DEVELOPMENT REVIEW BOARD

DEVELOPMENT REVIEW BOARD STAFF REPORT

Hearing Date: May 26, 2016	
Case No: DRB 2016-24	
Application(s): Minor Conventional Subdivision Sketch Plan	
Application Received: April 18, 2016	
Application Deemed Complete: April 21, 2016	
Staff Report Finalized: Monday, May 23, 2016	
Applicant(s): Connor and Meghann Rowley 501 Lake Road Milton, VT 05468 802-318-3544 connorowley13@aol.com	Owner(s): Rowley Family Real Estate c/o Lawrence Rowley 501 Lake Road Milton, VT 05468 802-893-7618
Engineer/License: Brian Tremback Lamoureux & Dickinson Consulting Engineers, Inc 14 Morse Drive Essex Junction, VT 05452	Surveyor/License: Doug Henson/ #656 Lamoureux & Dickinson Consulting Engineers, Inc 14 Morse Drive Essex Junction, VT 05452
E-911/Postal Address: 17 Dixon Road	
Tax Map, Parcel(s): 14, 6	
School Parcel Account Number(s) (SPAN): 13077	
Deed(s): Book 333, Page 894	
Existing Size: 255.1	
Zoning District(s): Agricultural Rural Residential "R5"	
Comprehensive Plan Planning Area/Sub-Area: West Milton Planning Area

Hearing Date: May 26, 2016	
Case No: DRB 2016-25	
Application(s): 2-lot Minor Conventional Subdivision Sketch Plan	
Application Received: April 29, 2016	
Ap

Property of Rowley Family Real Estate Lake Road / Hibbard Road Milton, VT	Project No. 15056 Survey -- Design BJT
Subdivision Sketch Plan	Drawn WEH/BJT Checked DJG Date 3-15-2016 Scale 1" = 200' Sheet number S1

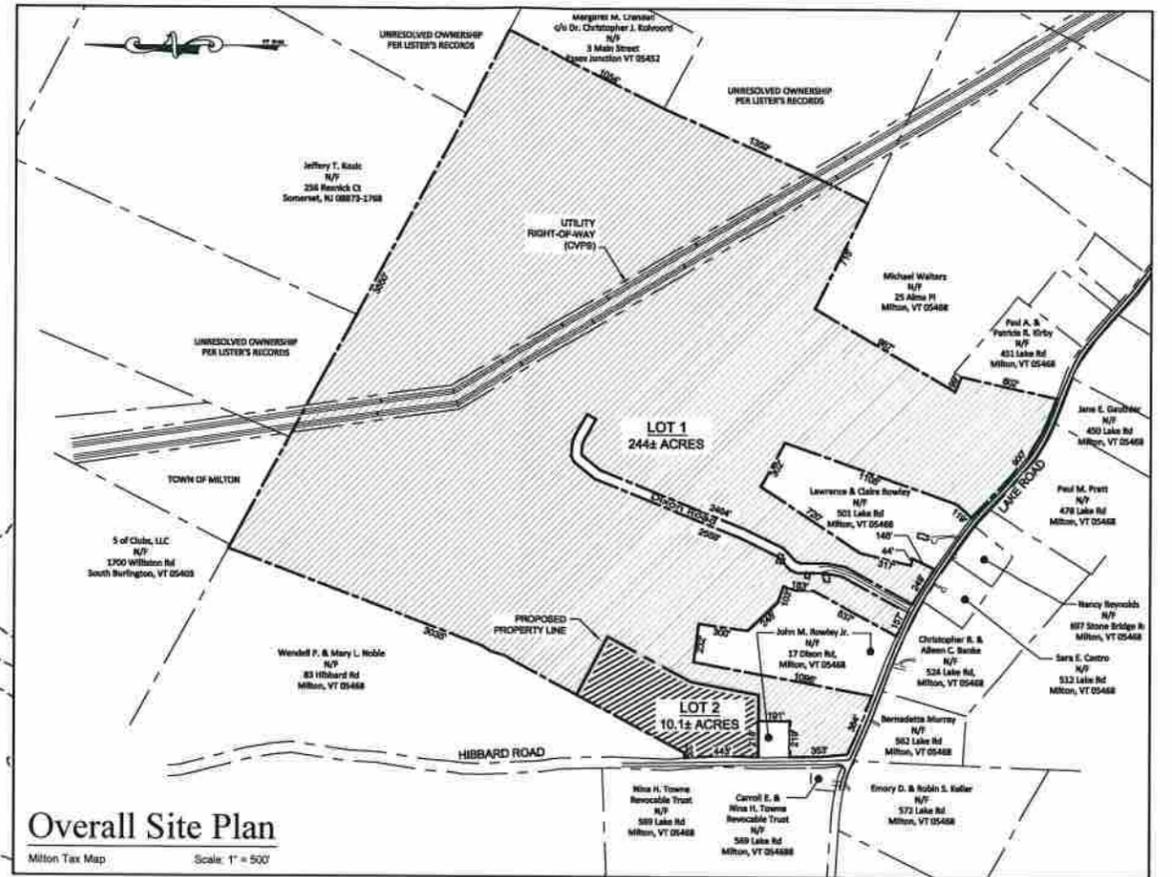
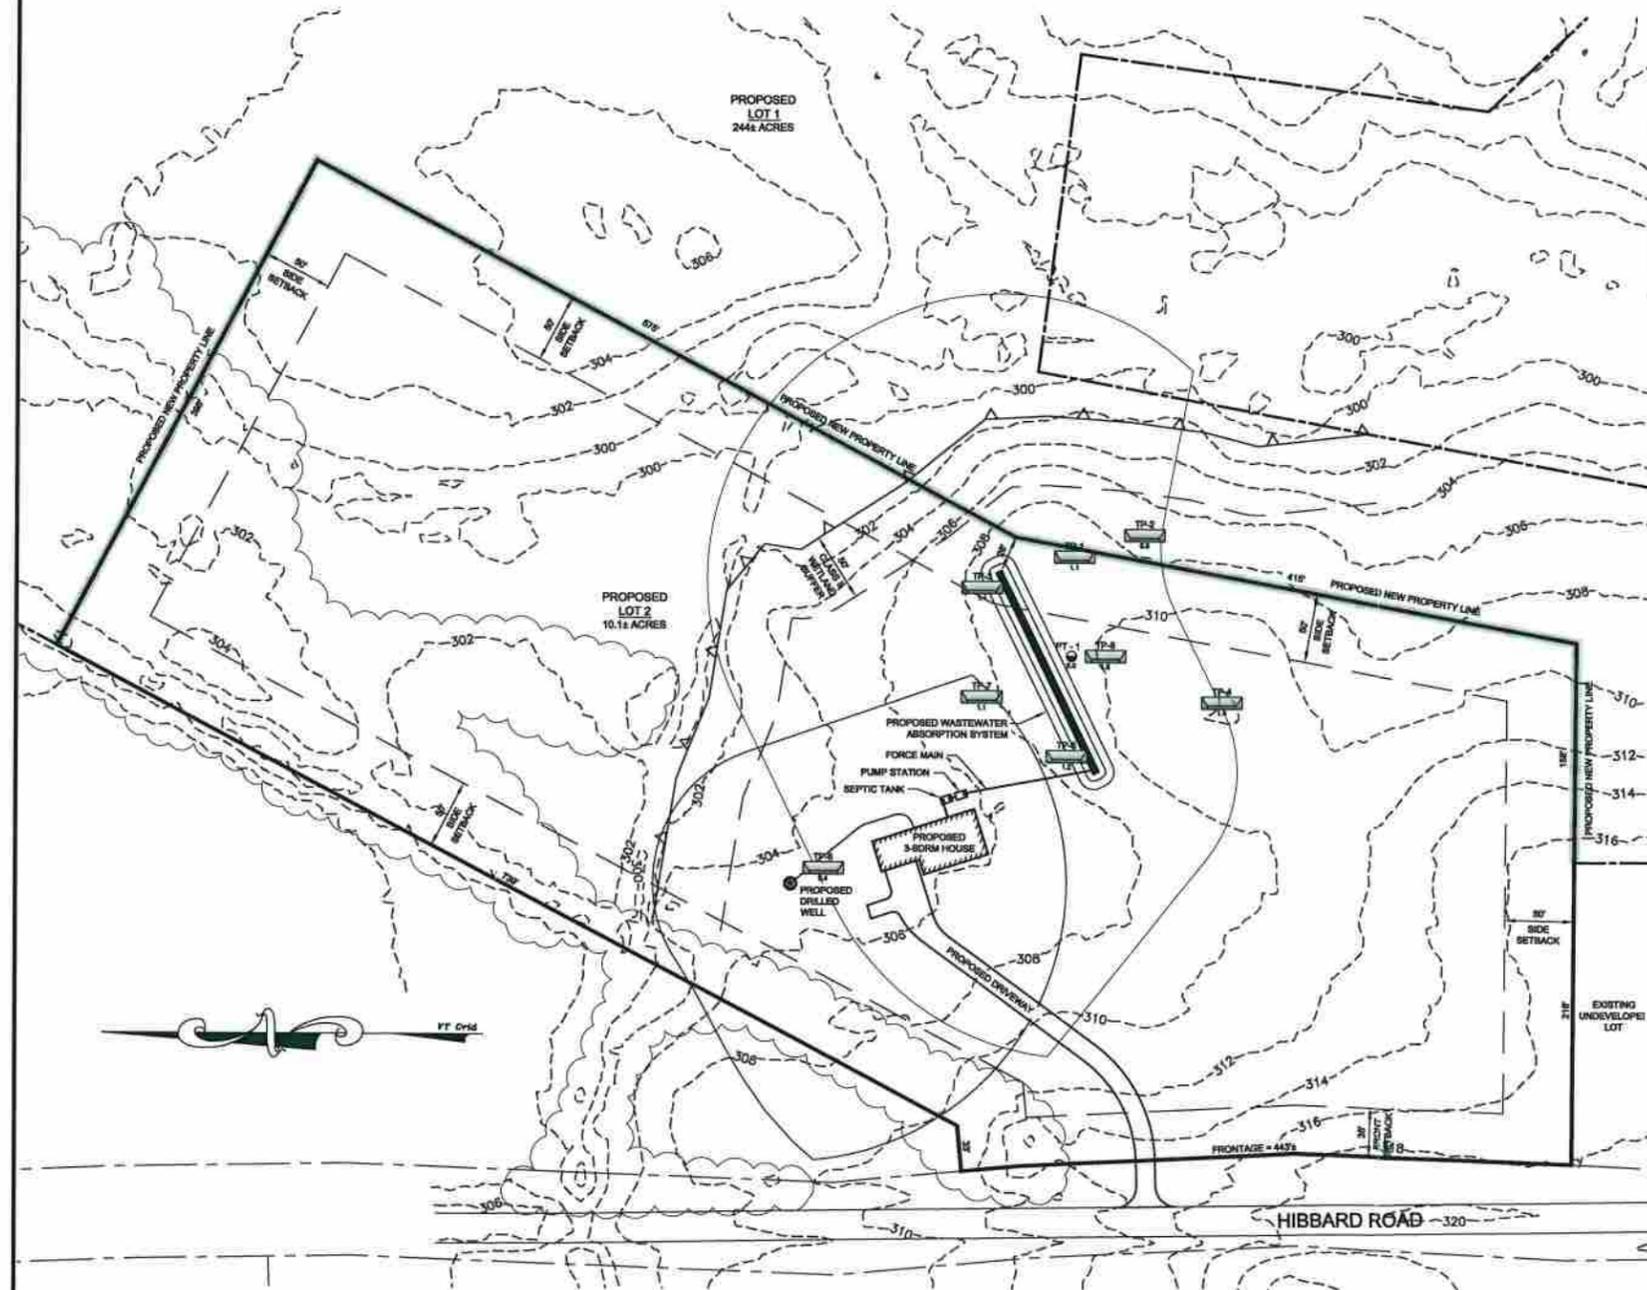
Existing Restrictions or Covenants: The application submitted indicates that the property is subject to an easement to Vermont Electric Power Company. The Sketch Plan submission labels a right-of-way to CVPS.

SR840, Drainage: No change to drainage on the site has been proposed. This item will be further addressed pending Sketch Plan approval. According to SR840, "Where a subdivision is traversed by a water course or drainage way there shall be provided a storm water drainage easement of such width as to encompass the twenty five (25) year flood area of such water course, which easement shall be indicated on the Final Plat."
